RE: Request for a TEDS Exception for On-Site Driveway Vehicle Storage Lengths

RE: Design Exception #03-07, 1<sup>st</sup> & Patterson Planned Development Driveway Vehicle Storage Length

## **DESIGN EXCEPTION #03-07**

RE: 1<sup>st</sup> & Patterson Planned Development

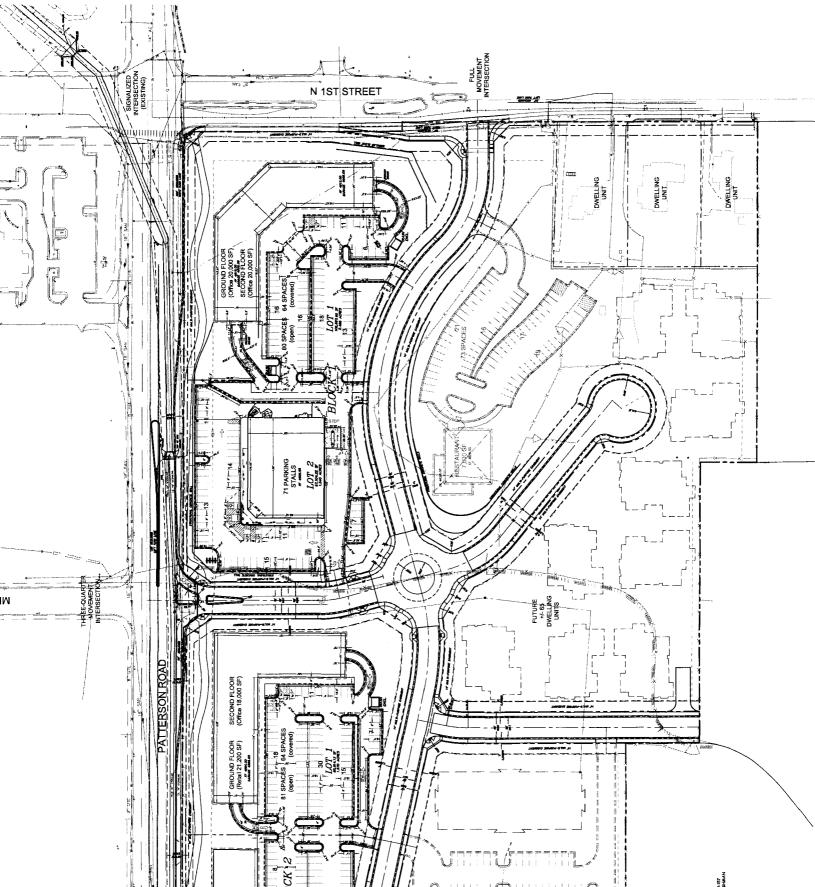
The applicant is requesting a reduction in the vehicle storage length for the driveway located on the lot line of Lots 1 and 2 in Block 1 (SE corner of Lot 2 and SW corner of Lot 1.) This would require exception to TEDS Section 4.2.5.1 Accesses Serving Off-Street Parking Lots which reads as follows:

The proposed design allows for a minimal number of curb cuts along the east/west road while providing for sufficient and safe access to two lots. The design proposes approximately 40 feet between the nearest street flowline and the first parking stall. It is important to note that the first parking stall is to the right of vehicles entering the site. Internal to the lots, left turn movements are not allowed until the driver has gone at least 150 feet into the site. The driveway immediately to the left when entering the site is a one way drive exiting the site. Left turn movements are not allowed.

TEDS 4.2.5.1 requires minimum onsite vehicle storage lengths of 50' at all accesses serving retail uses, and 25' at all accesses serving office uses. The applicant is requesting allowance for storage lengths of 40' and 25' at two of three shared accesses serving an office building and a retail store. They argue that the multiple accesses and the one-way aisle immediately adjacent to the shortest access, which prohibits onsite left-turns, mitigate the need for additional onsite vehicle storage.

Please find attached the committee's decision for the above referenced request. This design exception has been denied.
